ADDENDUM # 1

Warren County Bridge Replacement
Bridge #0570020 2
12/3/2021

<p>PSBA POEPPING, STONE, BACH & ASSOCIATES, INC. ARCHITECTS ENGINEERS PLANNERS SURVEYORS 100 S 54TH ST. P.O. BOX 709 • QUINCY, IL 62306 • PHONE 217-222-4805 3323 MAIN ST. P.O. BOX 817 • KEOKUK, IA 52652 • PHONE 319-524-8730 U.S. FEDERAL BUILDING, STE 224 • HANNIBAL, MO 63401 • PHONE 573-408-0541 www.psbai.com email: psbai@psbai.com</p>		<p>Designed MBW Drawn MBW Checked MJP</p>	<p>Surveyed TG Field Book Project No. C-20-053</p>	<p>Date 03/2021 Scale NOTED</p>	<p>Rev. Description</p>
<p>BRIDGE #0570020 1 WARREN COUNTY, MISSOURI END BENT NO. 2 DETAILS</p>					
<p>Sheet 11 11 of 18 Sheets File No.</p>

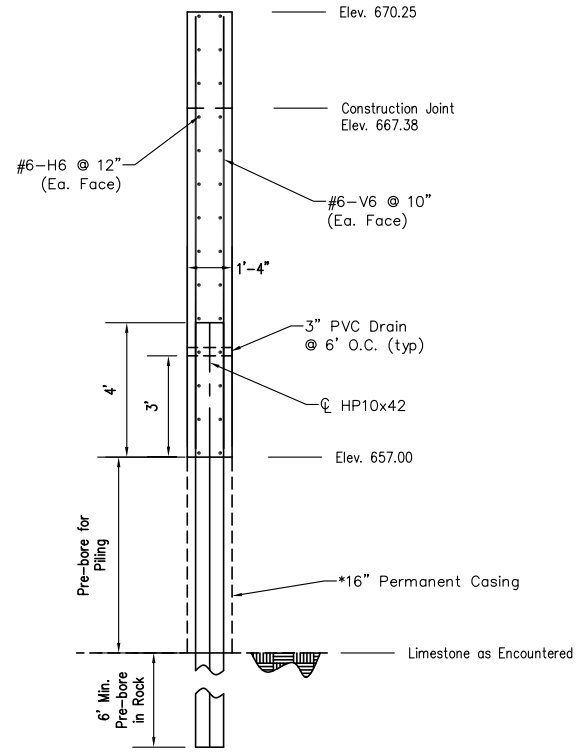
Please utilize the attached Bidding Form for bidding purposes. Also, replace Sheet 11 of 18 with the attached details. Note the addition of 16-inch Permanent Casing to contain the sand backfill of pre-boring. Also note the change in quantity of HP 10 x 42, HP 12 x 53 and Pre-bore for piling (to account for inconsistencies in bedrock encountered).

*16" Permanent not required should no void be encountered (as indicated in Boring B-2)..
